Application of PACIFIC GAS AND  
ELECTRIC COMPANY, a California  
corporation, for a Permit to Construct the  
Fulton-Fitch Mountain Reconductoring Project.

**PACIFIC GAS AND ELECTRIC COMPANY'S  
SECOND PETITION FOR MODIFICATION  
OF DECISION 17-12-012**

# **Second Supplemental Proponent's Environmental Assessment**

## **Fulton-Fitch Mountain Reconductoring Project**

**Figure 2.1-1**  
Proposed Access Route  
*Fulton-Fitch Mountain Reconductoring Project*

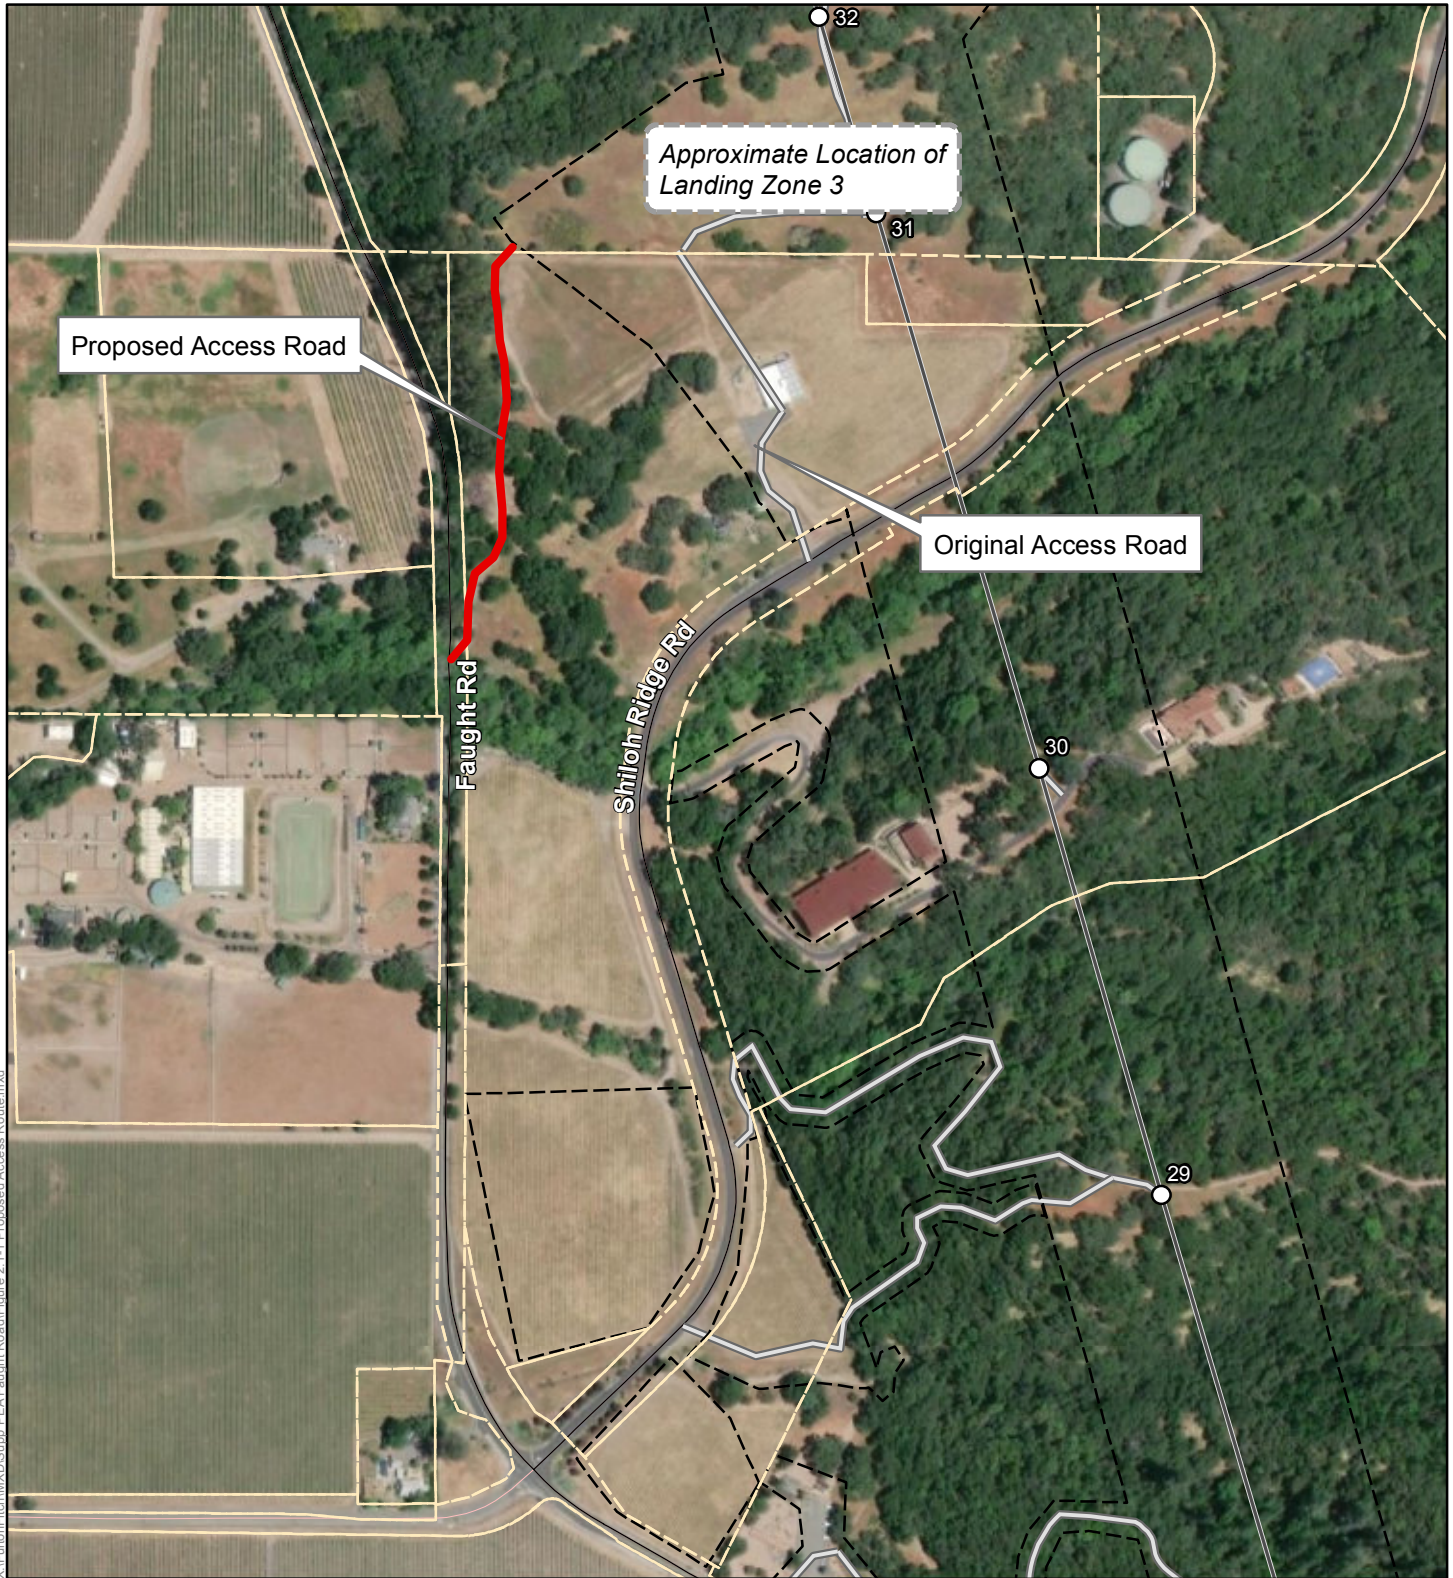
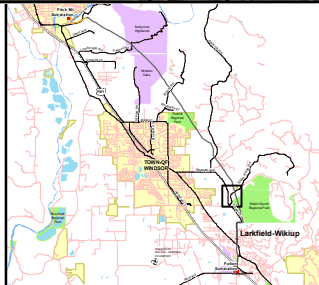
PG&E proposes to use a different route along an existing access road to reach Staging Area LZ-3. As shown on Figure 2.2-1, Proposed Access Route, the proposed 0.16-mile access route would extend from Faught Road, just north of Shiloh Ridge Road, to the western portion of Staging Area LZ-3. The new access route, approximately 845 feet long and totaling approximately 0.29 acres, would facilitate approved staging area activities, including helicopter landing, storing construction materials and equipment, refueling equipment and helicopters, parking vehicles and equipment, collecting construction waste prior to disposal, and conducting construction workforce meetings.

As shown on Figure 2.2-1, the approved project access to Staging Area LZ-3 utilizes an existing gravel road off Shiloh Ridge Road. Shiloh Ridge Road is a private paved road and provides the only access to the Mayacama Golf Course and residences belonging to two homeowners' associations. The Shiloh Home Owners Association (SHOA) has expressed concerns with traffic impacts, dirt/mud tracking and truck damage to the paved road surface concerning use of the approved project access road. The proposed access road will address the homeowners' association concerns by curtailing the need for project vehicles to travel on Shiloh Ridge Road. The proposed access is critical to enable staging and work activities for construction of the project.

Existing land uses along the proposed access route include a vineyard and private, open space. Surrounding land uses include pasture as well as additional vineyards and private, open space. Two residences are located along Faught Road, a public road, within 500 feet of the proposed access route. The proposed access road crosses two culverted water features.

**Figure 2.1-1 from the Supplemental PEA showing additional access route**
